Our Ref: 20180C.12RP_RFI Response Letter

**RE: SSD-10291 PROPOSED SENIOR SCHOOL CAMPUS AND SPORTS CENTRE
ST LUKES GRAMMAR SCHOOL
210 HEADLAND ROAD AND 800 PITTWATER ROAD DEE WHY AND 224
HEADLAND ROAD, NORTH CURL CURL**

Table 1: Responses to TfNSW Letter dated 16 November 2021

View 02b - Pedestrian Fence Line of Sight - approaching from West (from Warringah Road) - **REVISED LANDSCAPING WALLS**

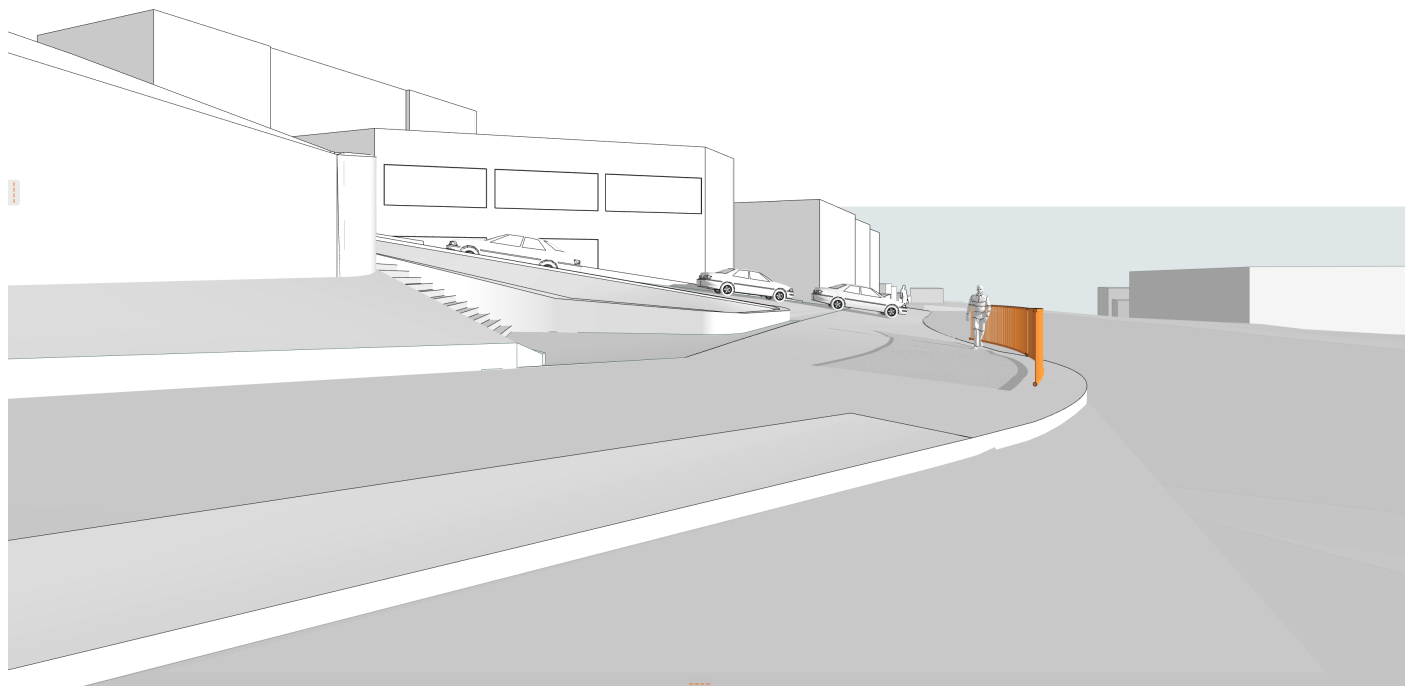
As discussed in **Table 1**, the crash study and review concluded that two (2) of the motor vehicle crashes involved motorists making illegal movements in the vicinity of the existing driveway. However, the crash study and review report recommended that improvements in delineation and guidance in the existing driveway should be implemented to emphasise left turn only out of the driveway onto Harbord Road. The proposed development includes upgrades to the existing driveway including new line-marking. In addition, new pedestrian fencing and a large waiting area is provided in the vicinity of the pedestrian crossings (**Figure 7**). In accordance with the proposed Senior School Traffic Management Plan, this location will be supervised during peak Senior School pick-up and drop-off periods to ensure that students cross the road safely.

View 02b - Pedestrian Fence Line of Sight - approaching from West (from Warringah Road) - **REVISED LANDSCAPING WALLS**
